# Exhibit B

## 1991 Lake Pickett Cluster Plan

Proposed Additional Conditions to be added as Conditions 30-33 to  
Lake Pickett Cluster Parcels 1, 2, & 3

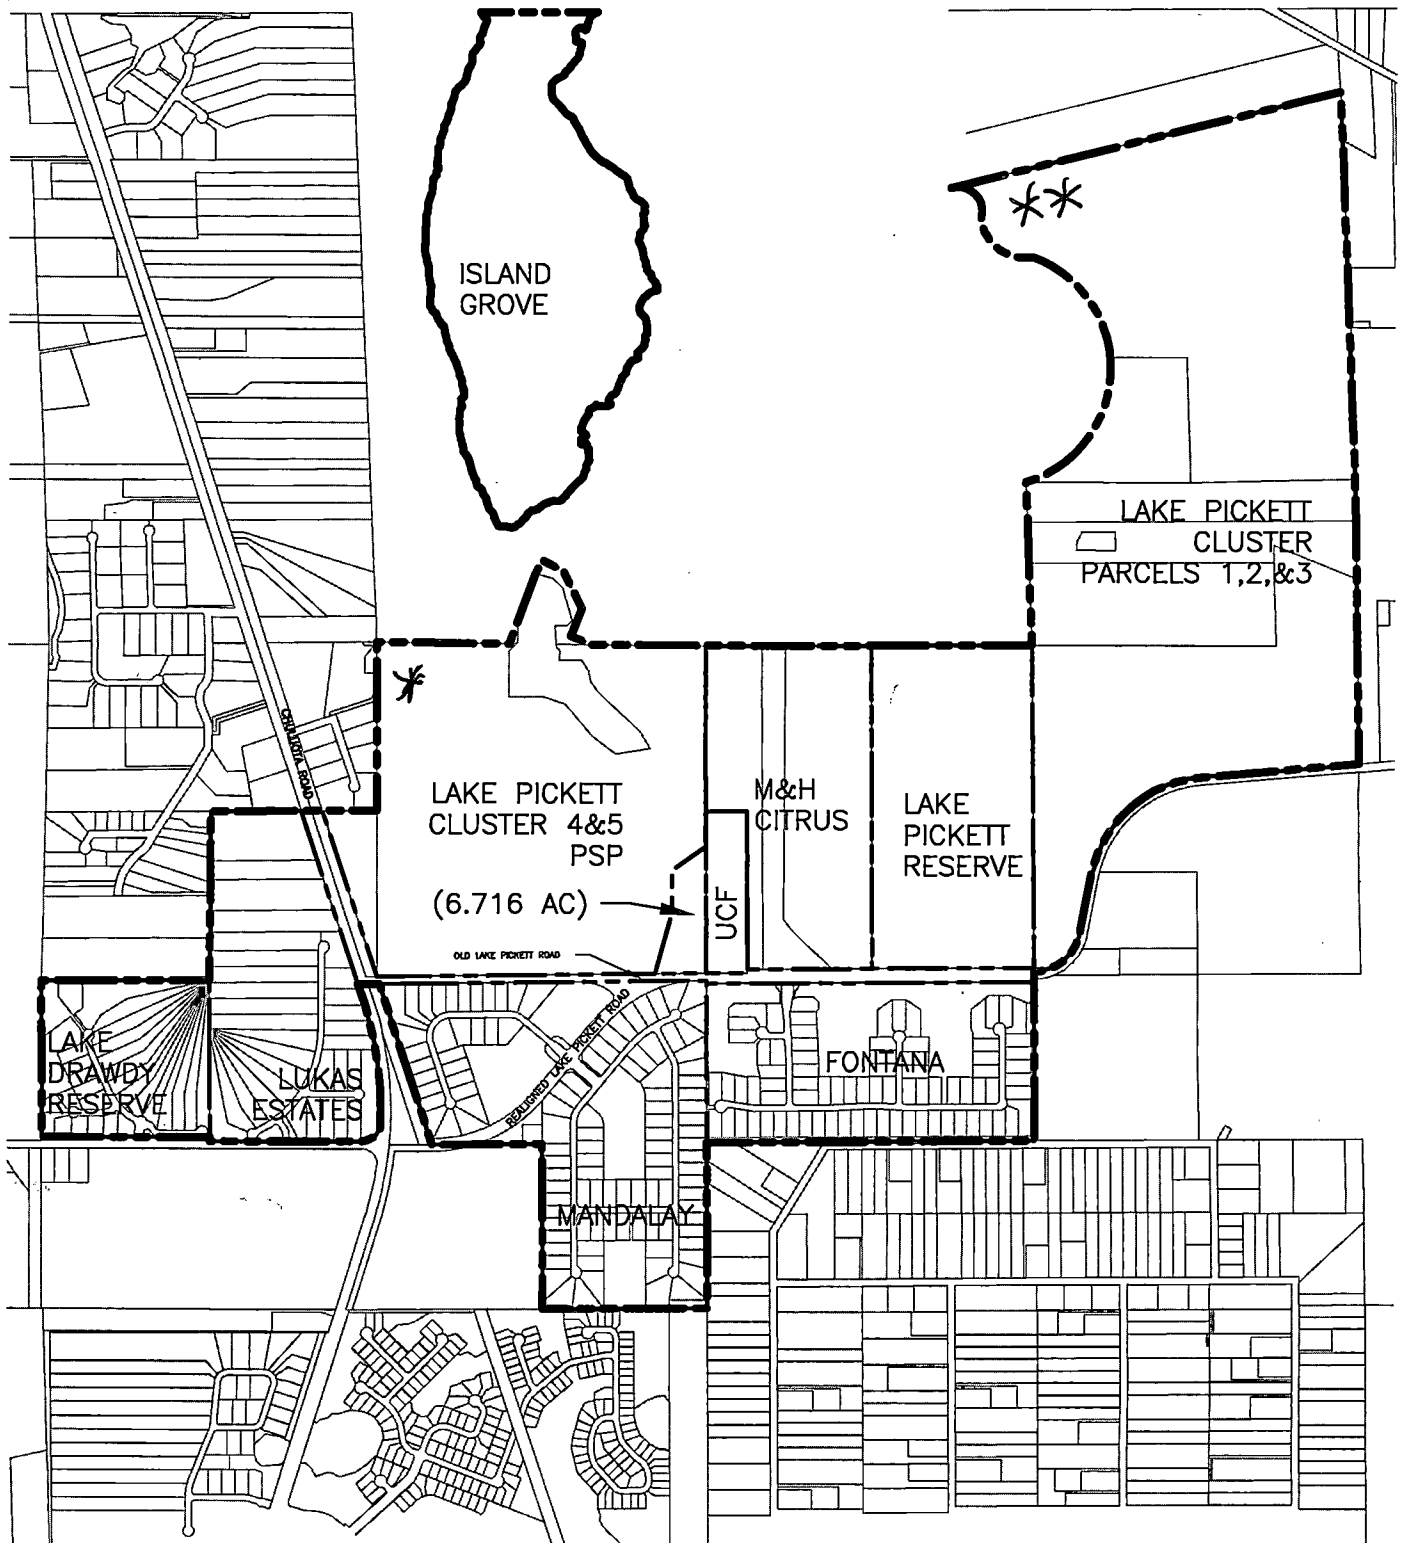
The wall shall  
have off sets of  
2 feet  
minimum of 20 feet

-look aluminum  
fences  
A wrought iron  
pillars shall be  
installed along  
the  
retention  
ponds &  
submittal to  
Lake P.  
Road  
frontage

30. A 6-foot tall screen wall/fence along lots 168-182 within a 10-foot wide easement per Sec. 15-304-209. Wall may be brick, stone, CMU with a brick or artificial stone veneer, precast, or some combination thereof with integrated decorative caps. A continuous hedge along the wall, except where understory trees are planted, along the same lots and within the same easement as the wall/fence. Understory trees planted 30-foot on center along the same lots and within the same 10-foot wide easement as the wall/fence and hedge.

31. Two of the six trees to be planted on lots 168-182 as required by Sec 15-306 will be located near the wall/fence to provide a visual buffer to the rear of the houses.

32. Subdivision lighting will be consistent with Orange County lighting code and will contain full cutoff fixtures.
33. The rear setback for lots 168-182 will be increased to 50 feet.
